# HISTORIC AND DESIGN REVIEW COMMISSION

**HDRC CASE NO:** 2017-467  
**ADDRESS:** 423 N HACKBERRY ST  
**LEGAL DESCRIPTION:** NCB 576 BLK 15A LOT N 30.32 FT OF 12  
**ZONING:** RM-4 H  
**CITY COUNCIL DIST.:** 2  
**DISTRICT:** Dignowity Hill Historic District  
**APPLICANT:** John Brearley  
**OWNER:** John and Irene Brearley  
**TYPE OF WORK:** New construction of a 2-story single family home  
**APPLICATION RECEIVED:** October 17, 2017  
**60-DAY REVIEW:** December 16, 2017  
**REQUEST:**

The applicant is requesting conceptual approval to construct a new two-story single family home on the vacant lot at 423 N Hackberry.

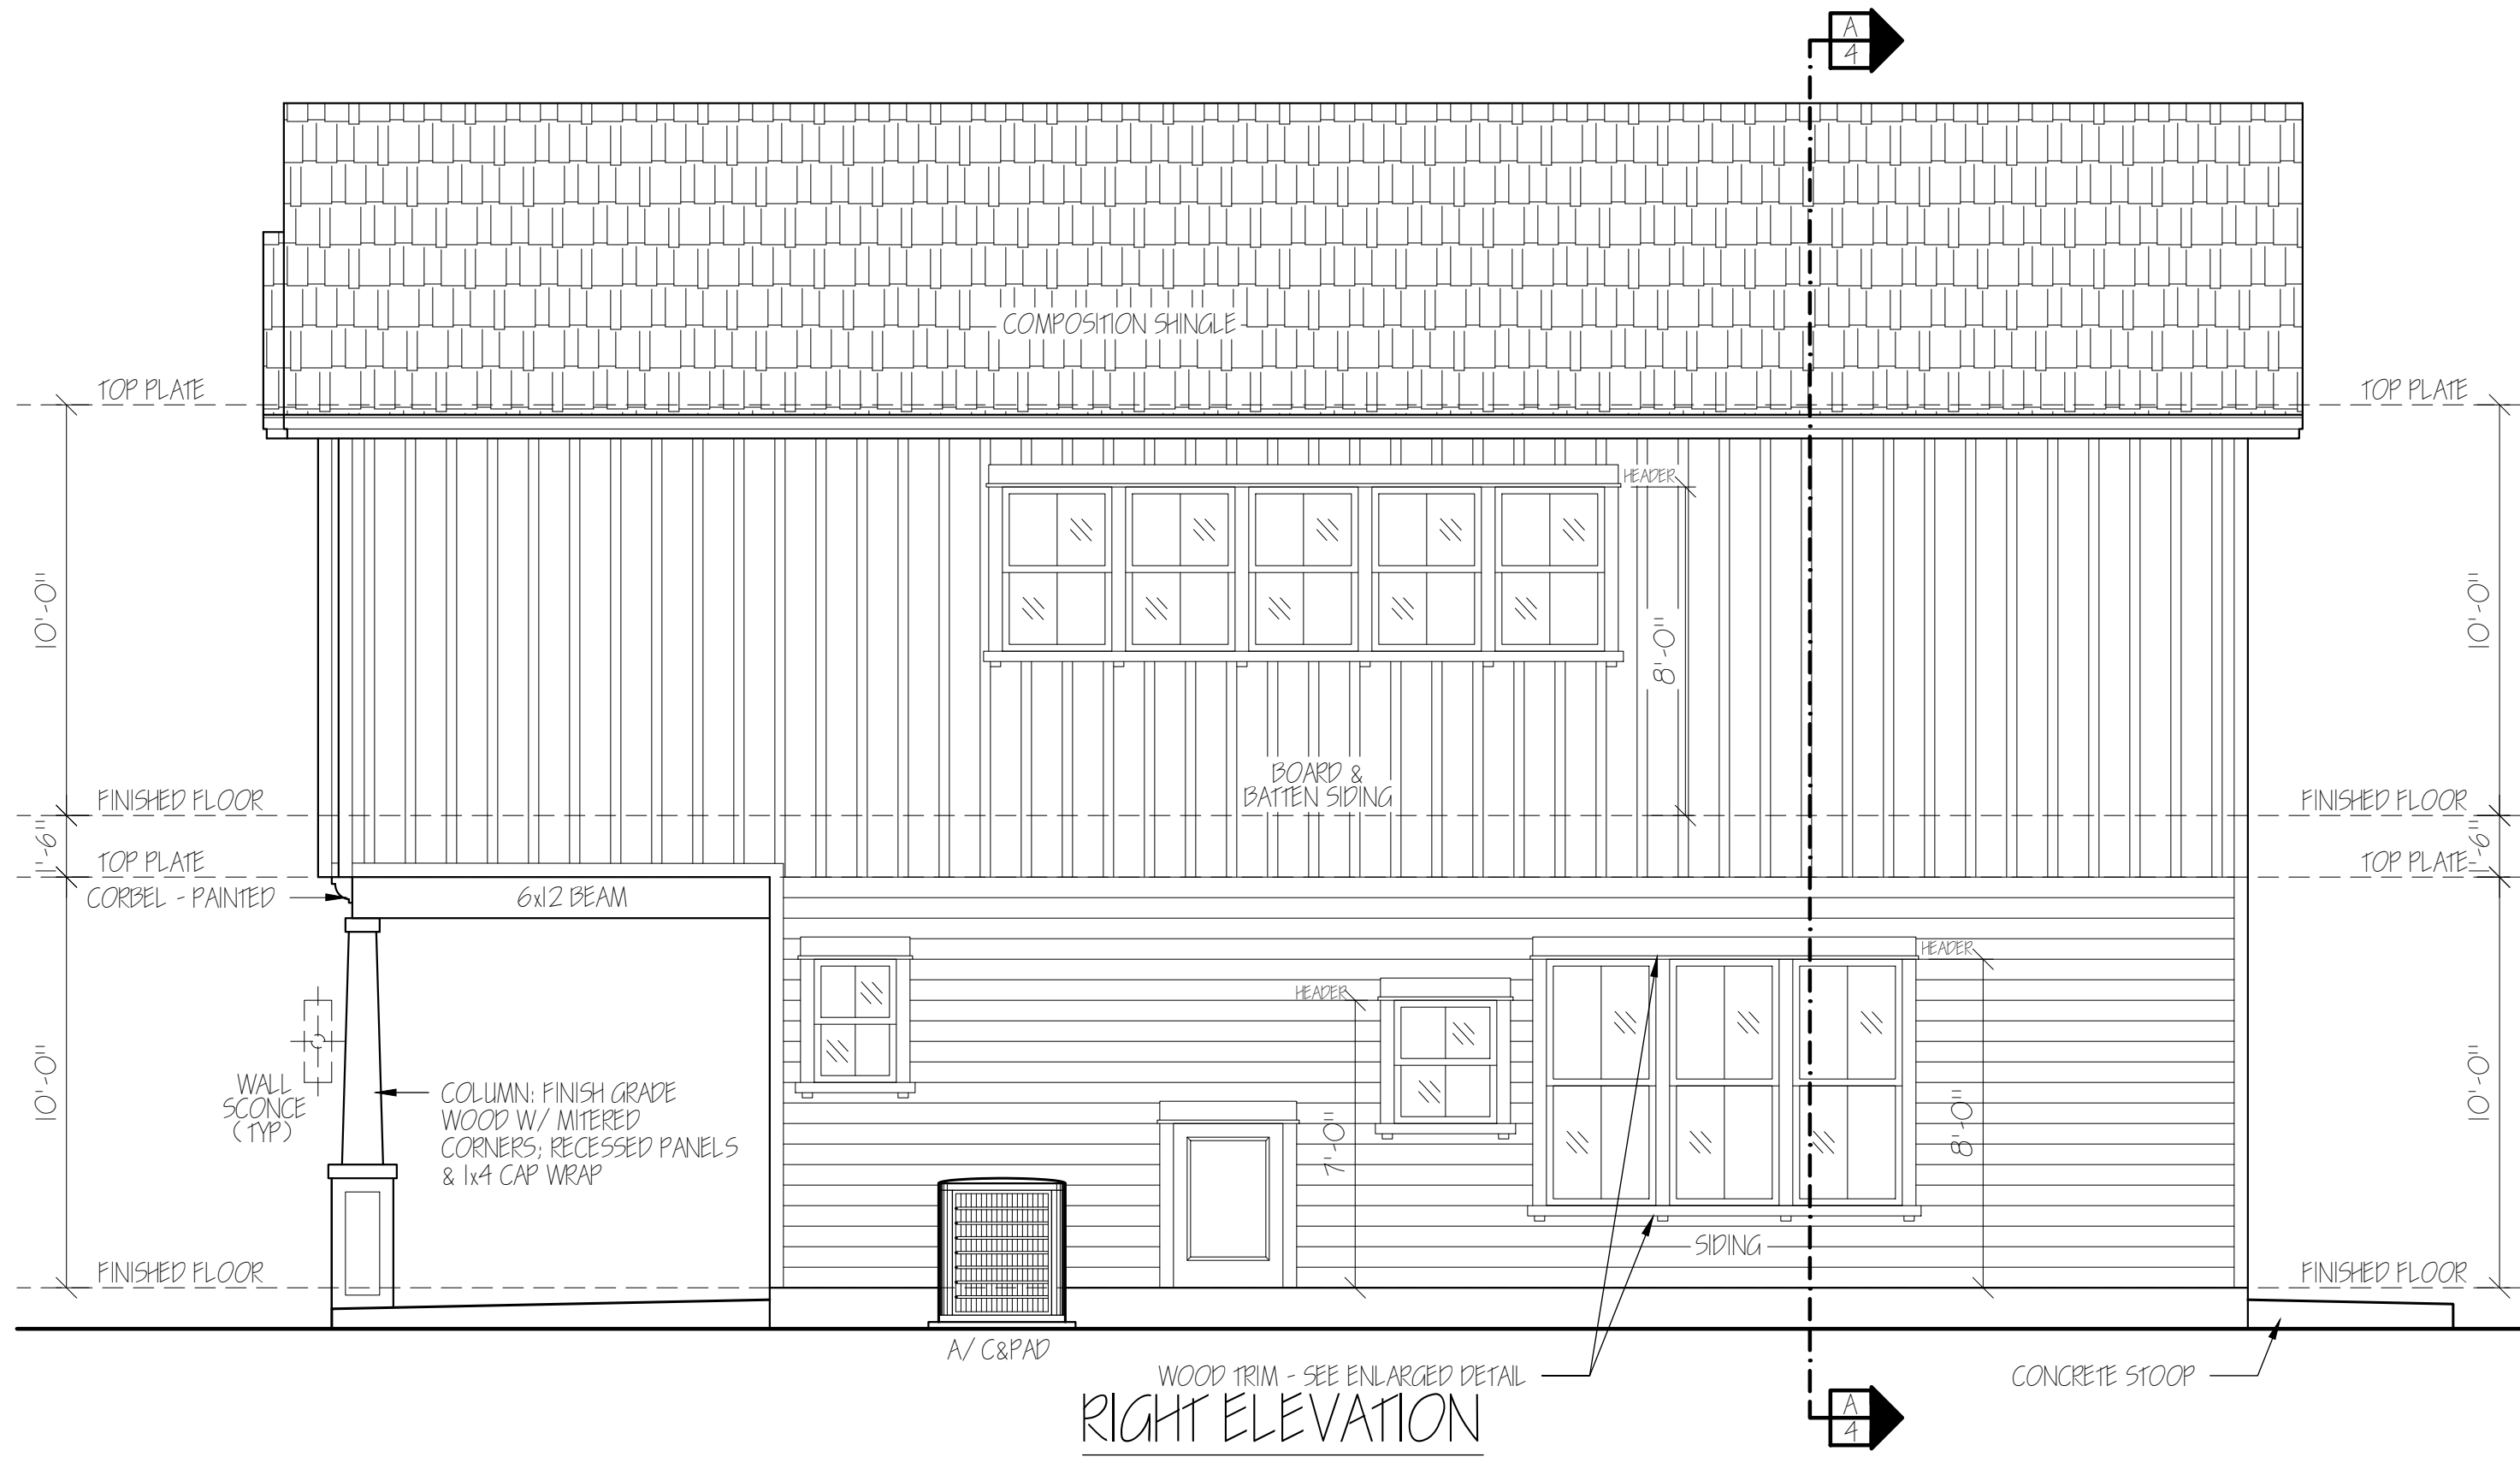
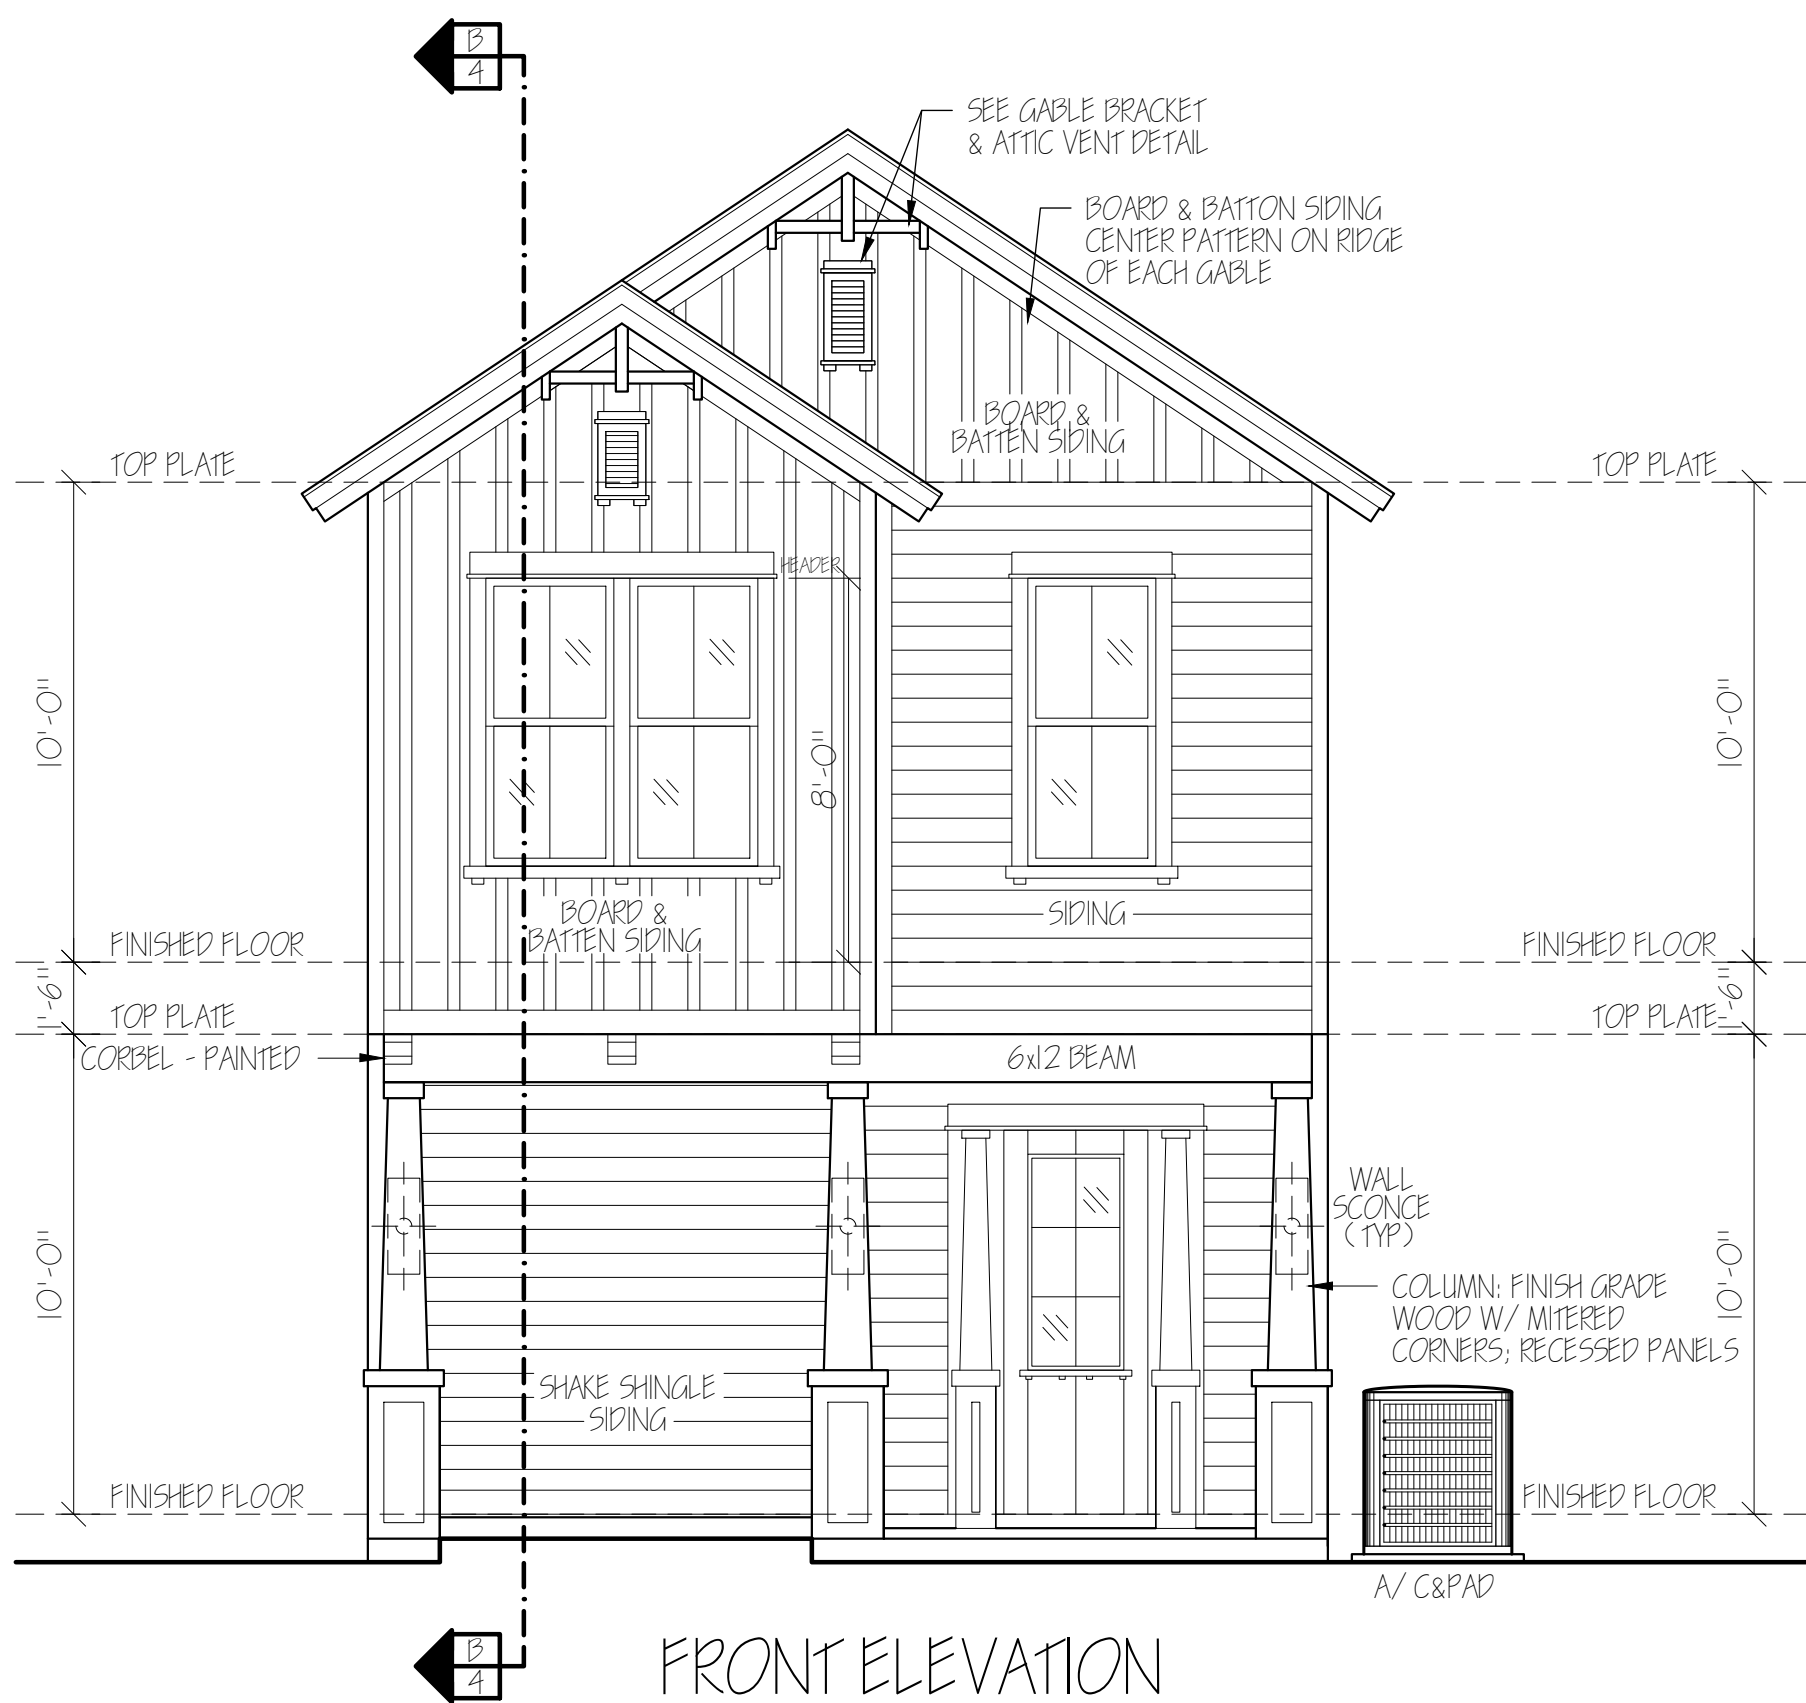
- f. **SCALE & MASS** – Per the Guidelines for New Construction 2.A.i., a height and massing similar to historic structures in the vicinity of the proposed new construction should be used. In residential districts, the height and scale of new construction should not greatly exceed the historic precedent. The only remaining historic residential structure on N Hackberry between E Houston and Glorietta is 2 stories. The remaining historic structures in the vicinity on Glorietta are 1-story. The applicant has noted on the submitted drawings that the proposed ridge line will be 28'-10" from the finish floor, which is approximately one foot from grade, bringing the total height to approximately 29'-10" feet. Both the first and second stories will feature 10'-0" tall interior ceiling heights separated by a web truss measuring 1'-6". The neighboring 2-story historic structure features a first floor ceiling height of 10'-0" and a second floor ceiling height of 8'-0". Staff does not find the proposed height to be consistent with the Guidelines. Staff finds that the overall height should be reduced through the shortening of the second story or the lowering of the top plate height to produce an overall height that is comparable with the heights of neighboring, historic structures.

- g. **PORCH CONFIGURATION AND MASSING** – The applicant has proposed to incorporate a front porch on the front façade of the new structure. The porch mass will be inset approximately 6" from the front façade. The Historic Design Guidelines state that porches on new construction should be reflective of the development pattern of the district. Typically in historic districts, including Dignowity Hill, residential porch massing elements project the furthest towards the streetscape to engage pedestrians. Two story structures feature a second story that is set back from the porch. As proposed, the structure's second story extends over the front porch, which increases the massing on the street. This is addressed in Guideline 2.A.ii, which states that step-downs in building height, wall-plane offsets, and other variations in building massing to provide a visual transition should be utilized. There is no historic precedent in the district for this porch form or massing strategy. Staff finds the porch inconsistent with the

- j. **WINDOW & DOOR OPENINGS** – Per the Guidelines for New Construction 2.C.i., window and door openings with similar proportions of wall to window space as typical with nearby historic facades should be incorporated into new construction. The applicant has proposed window and door openings that are generally consistent with those found on historic structures in regards to location and size with the exception of the right and left elevations, which feature several small fixed windows that are not consistent with the OHP Window Policy Document or historic fenestration precedents in the district, as well as a series of ganged windows with minimal trim separation between them. All proposed window detailing can be modified to relate closer to historic examples, such as the use of approximately six inches of separation between double windows. Each window should be inset at least two (2) inches within walls to ensure that a proper façade depth is maintained.

1. That the applicant provides information noting the setbacks of adjacent historic structures on a contextual site plan.
2. That the applicant reduces the proposed height through the shortening of the second story or the lowering of the top plate height to produce an overall height that is comparable with the heights of neighboring historic structures.

3. That the applicant sets the second story back from the front façade and modifies the front porch configuration and massing as noted in finding g. The porch should be the mass that projects furthest towards the streetscape to reflect the developmental context of the area.

4. That the proposed driveway extends along the side of the proposed new construction as noted in finding p.
5. That the applicant introduces window sizes and proportions that are more consistent with the Historic Design Guidelines, the OHP Window Policy Document, and adjacent historic structures to the right and left elevations as noted in finding i.
